SUBJECT: WOLF CREEK GENERATING STATION - AMENDMENT NO. 23 TO FACILITY
OPERATING LICENSE NO. NPF-42 (TAC NO. 68648)

KANSAS GAS & ELECTRIC COMPANY
KANSAS CITY POWER AND LIGHT COMPANY
KANSAS ELECTRIC POWER COOPERATIVE, INC.
WOLF CREEK GENERATING STATION
DOCKET NO. 50-482
AMENDMENT TO FACILITY OPERATING LICENSE

Amendment No. 23
License No. NPF-42

ATTACHMENT TO LICENSE AMENDMENT NO. 23

FIGURE 3.2-3

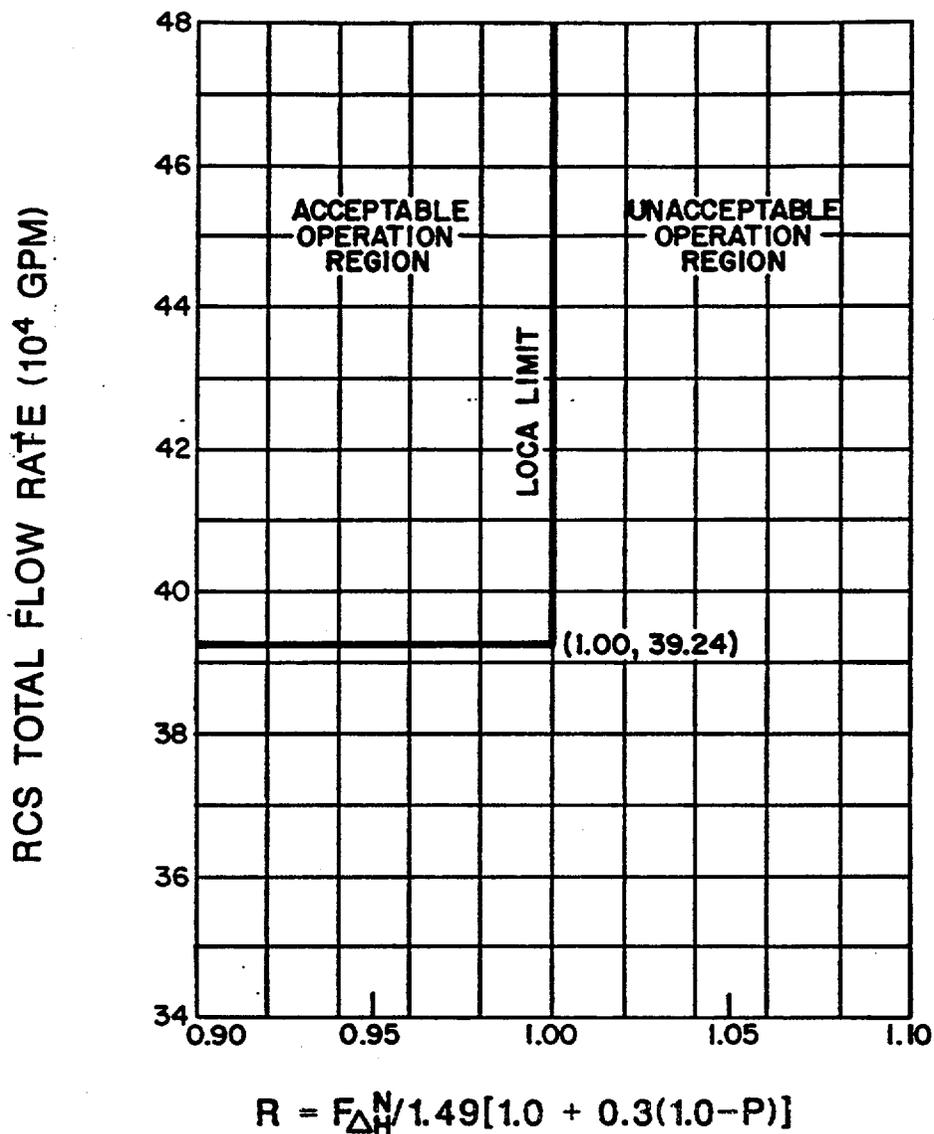
3.2.3 The combination of indicated Reactor Coolant System (RCS) total flow rate and R shall be maintained within the region of allowable operation shown on Figure 3.2-3 for four loop operation.

c. $F_{\Delta H}^N$ = Measured values of $F_{\Delta H}^N$ obtained by using the movable incore detectors to obtain a power distribution map. The measured values of $F_{\Delta H}^N$ shall be used to calculate R since Figure 3.2-3 includes measurement uncertainties of 2.5% for flow and 4% for incore measurement of $F_{\Delta H}^N$.

When RCS flow rate and $F_{\Delta H}^N$ are measured, no additional allowances are necessary prior to comparison with the limits of Figure 3.2-3. Measurement errors of 2.5% for RCS total flow rate and 4% for $F_{\Delta H}^N$ have been allowed for in determination of the design DNBR value.

Based on the information presented in the licensee's letter dated June 24, 1988, the staff has concluded that the licensee's proposed changes to Technical Specifications 3.2.3, 3.1.2.5, 3.1.2.6, 3.5.1, 3.5.5, 3.10.4, Figure 3.2-3, Table 2.2-1 and corresponding Bases are therefore acceptable.

MEASUREMENT UNCERTAINTIES OF 2.5% FOR FLOW
 AND 4.0% FOR INCORE MEASUREMENT OF $F_{\Delta H}^N$
 ARE INCLUDED IN THIS FIGURE
